# Technical Service Information

## THM 4L60 (700-R4)

### 3-2 COAST DOWN CLUNK (CORVETTE ONLY)

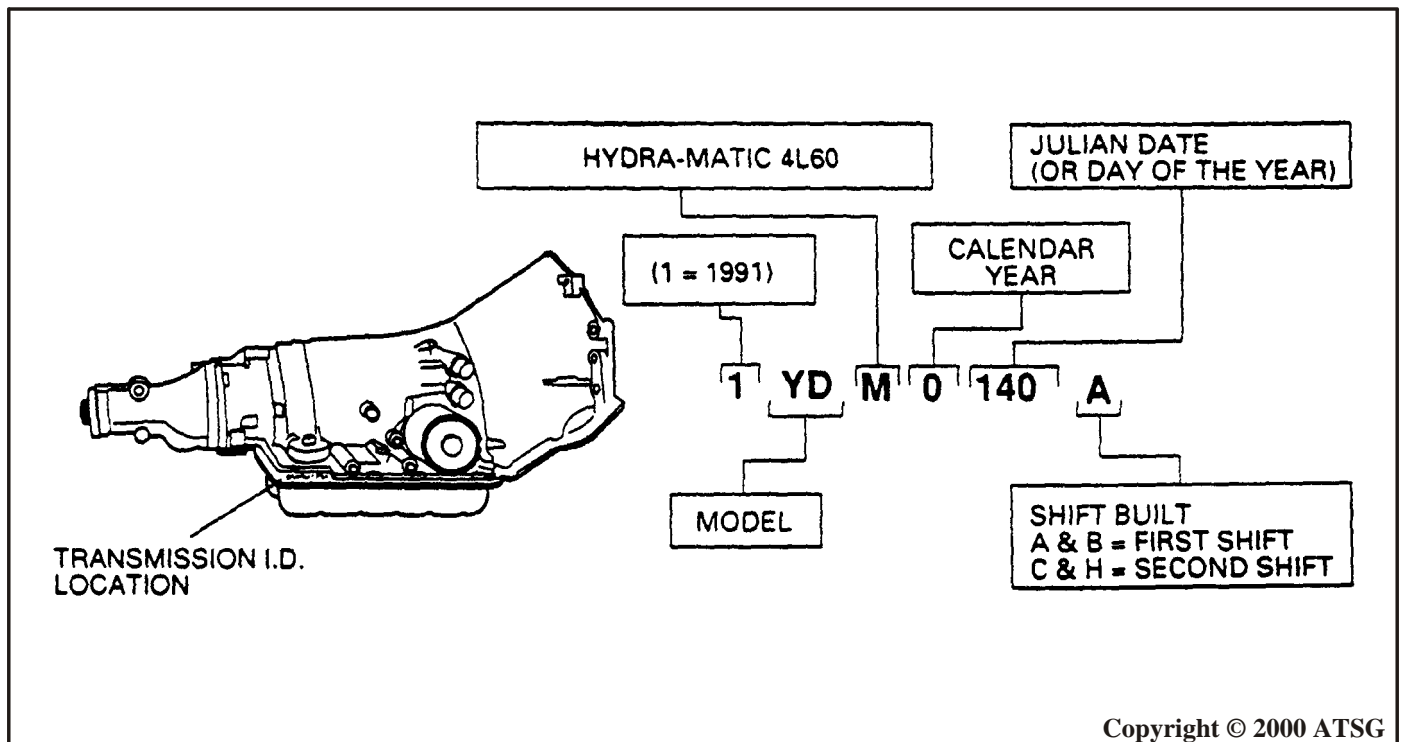
**NOTE:** Beginning May 20, 1991 (Julian Date 1401, all 1YHM models were built using the new servo cushion assist spring and spacer plate. Use the Figure below to determine if the modification is necessary in your transmission.

Figure 1

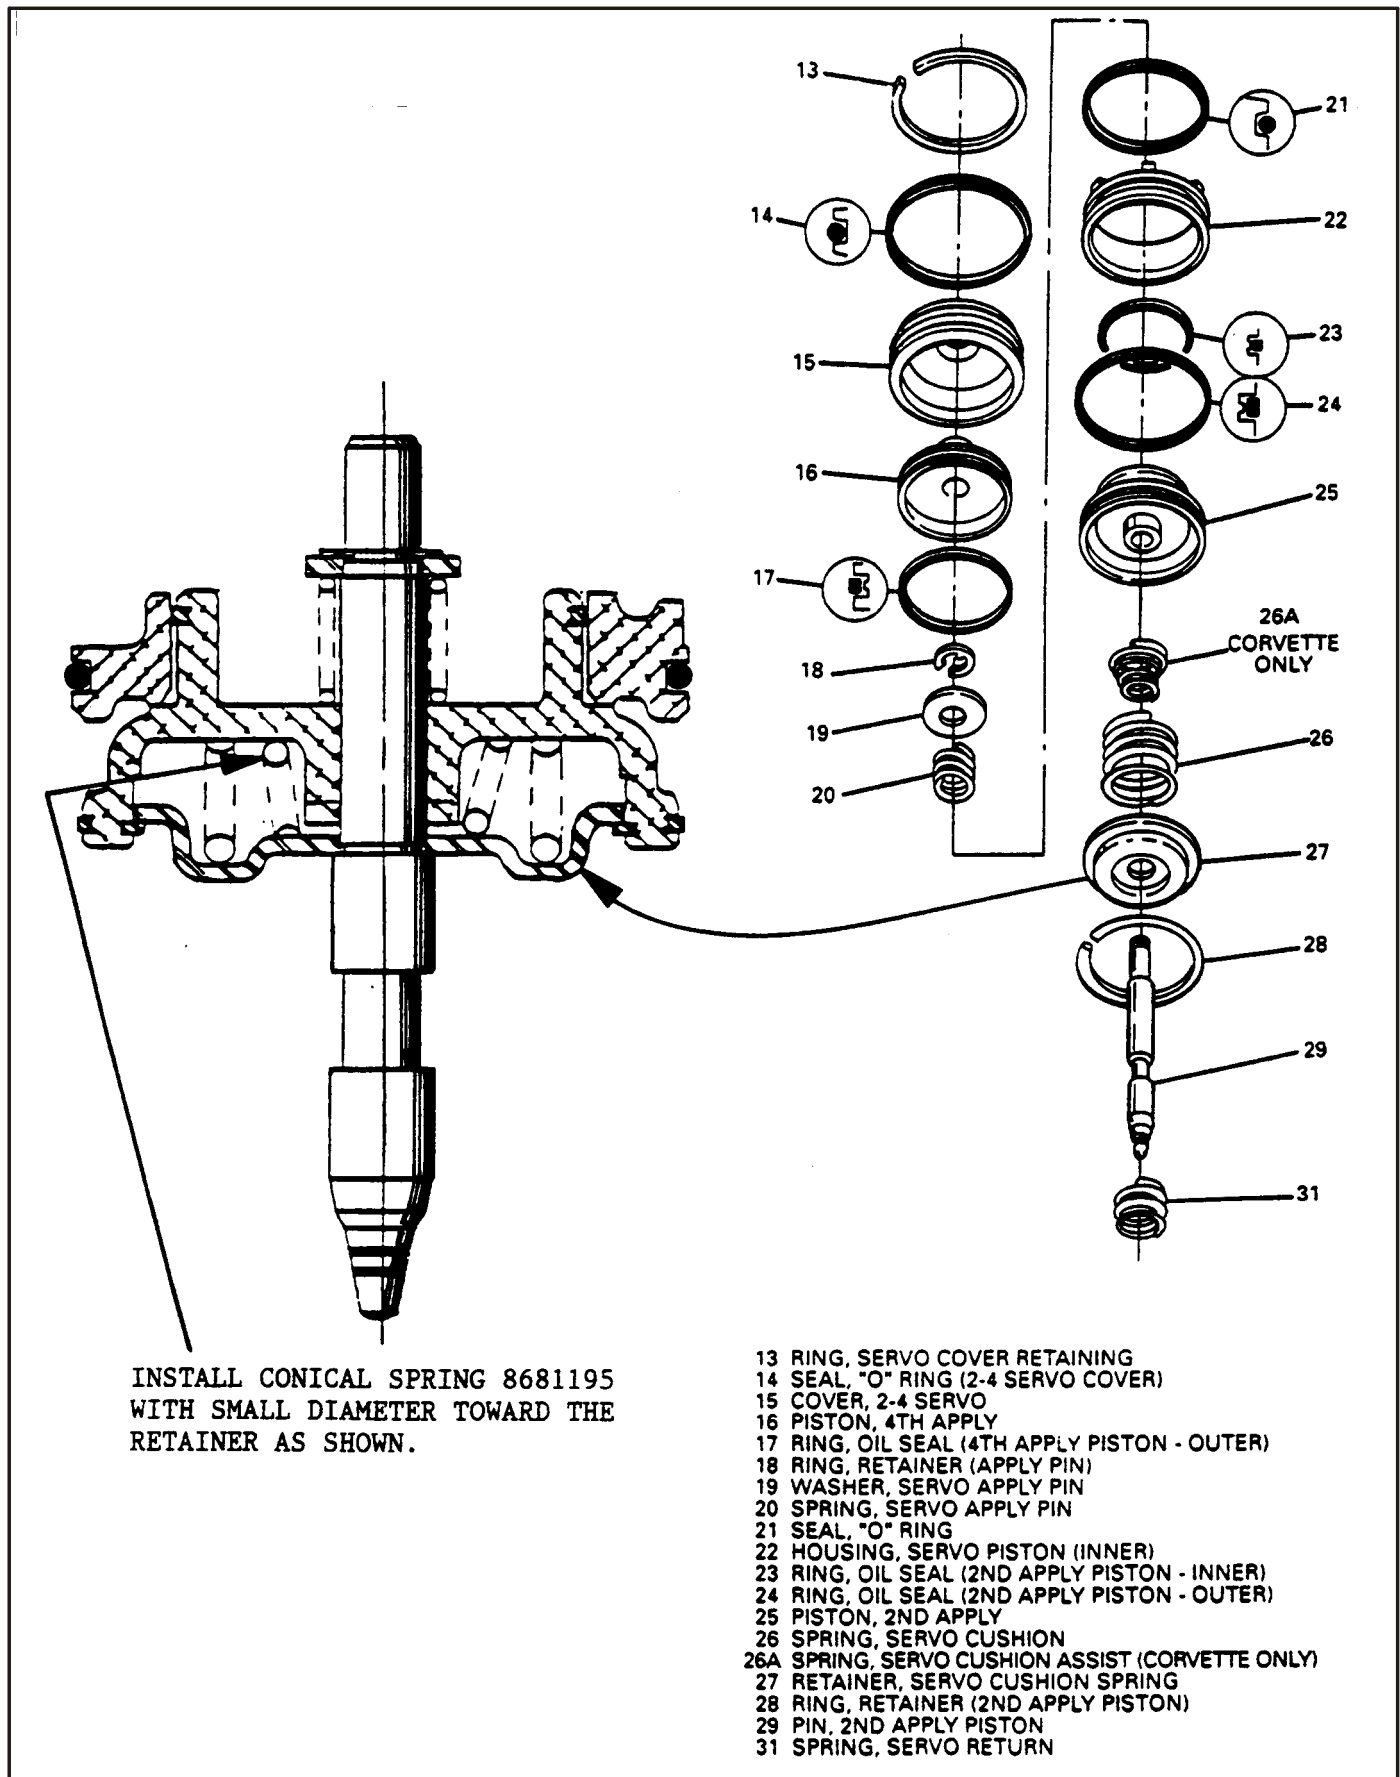
**CAUSE:** The cause may be, timing of the release of the 3-4 clutch and re-apply of the 2-4 band. A new conical 2-4 servo cushion assist spring has been released to alleviate this condition, along with enlarging the 3rd clutch exhaust hole in the spacer plate.

**CORRECTION:** (1) Install the new conical 2-4 servo cushion assist spring, OEM part number 8681195, inside of the current servo cushion spring with the small end towards the retainer, as shown in Figure 1.

Conical 2-4 Servo Cushion Assist Spring..... 8681195

Figure 2

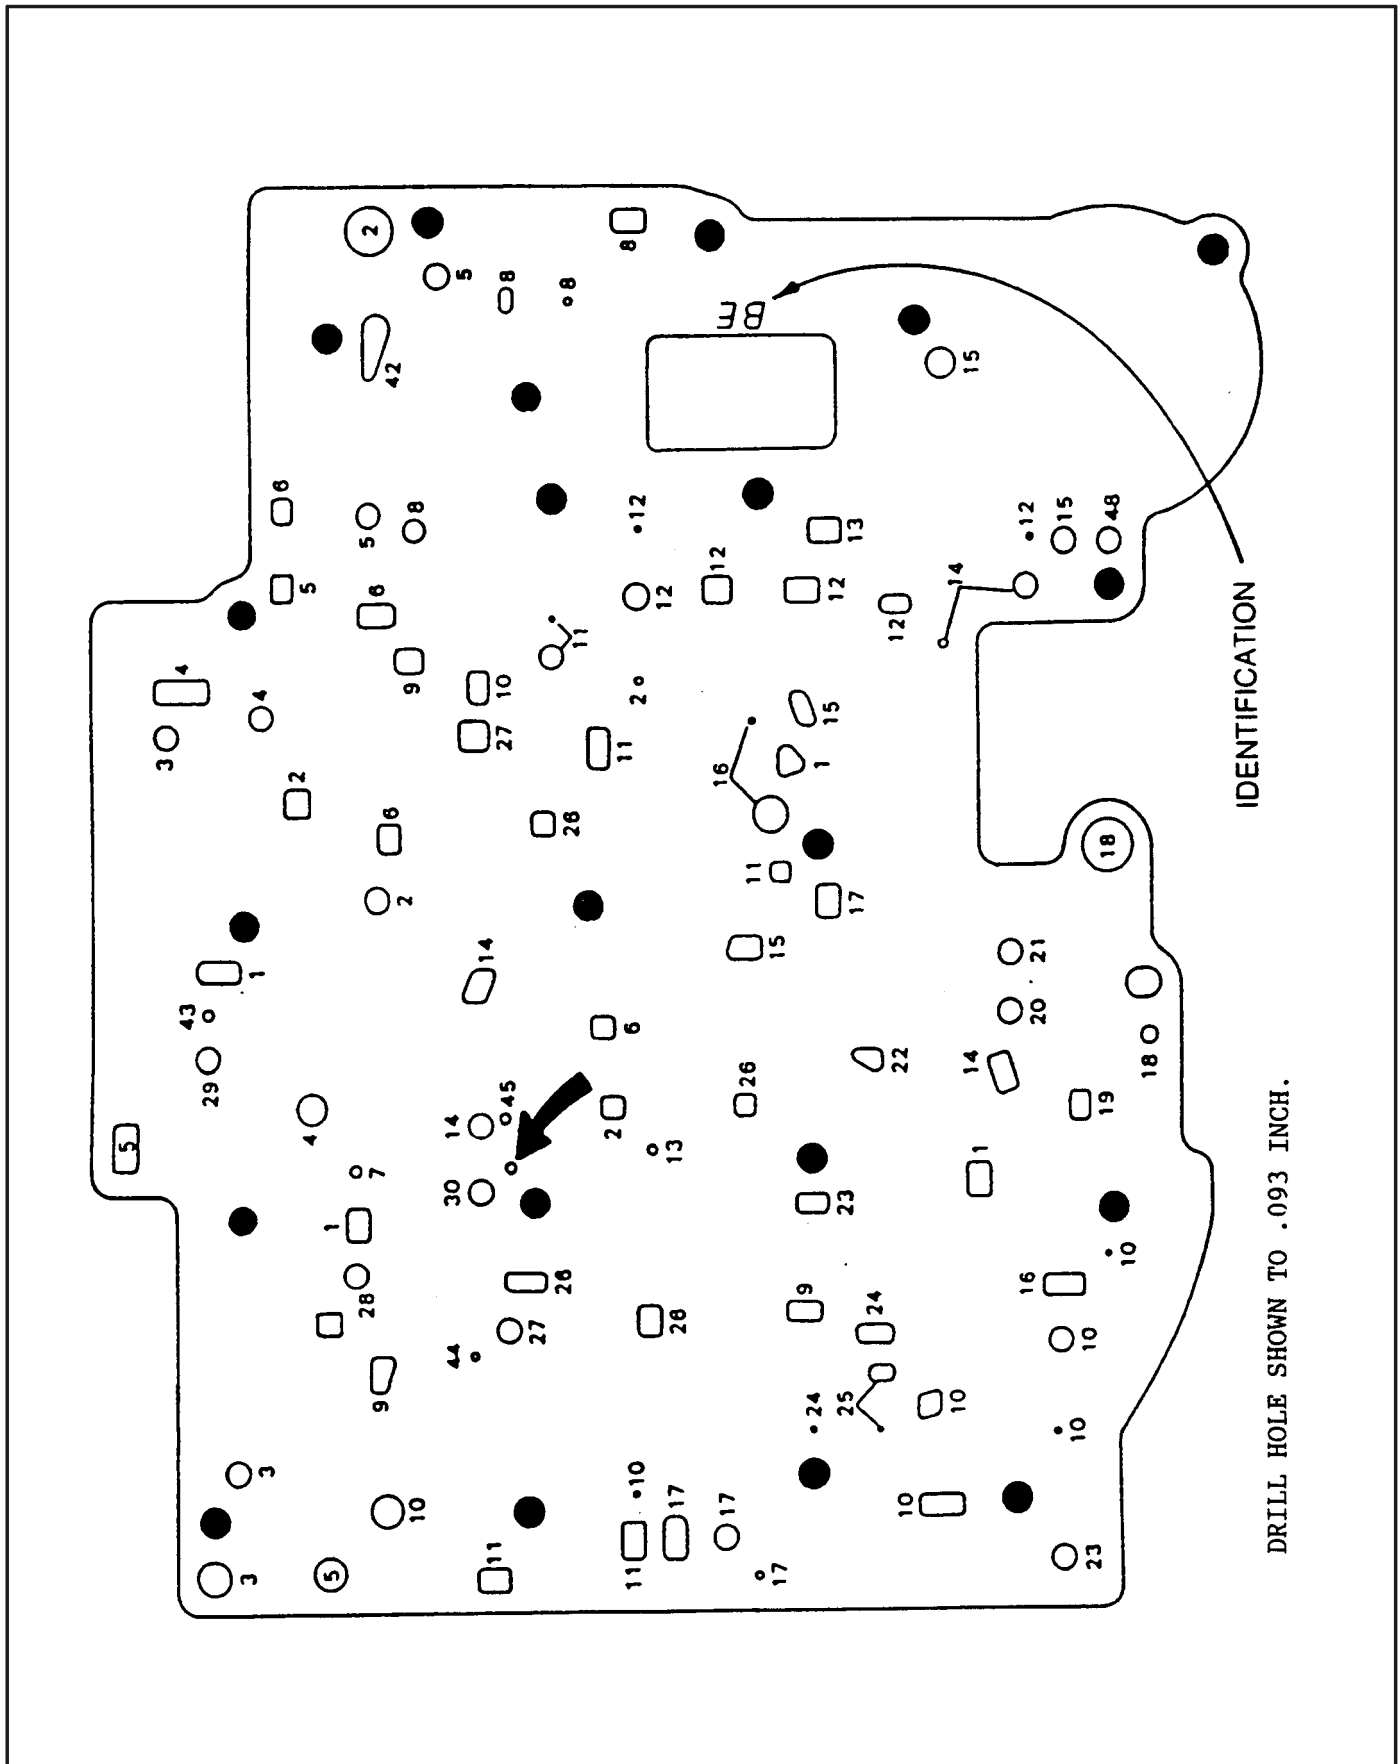
(2) Enlarge the 3rd clutch exhaust hole in the spacer plate to .093", as shown in Figure 2.
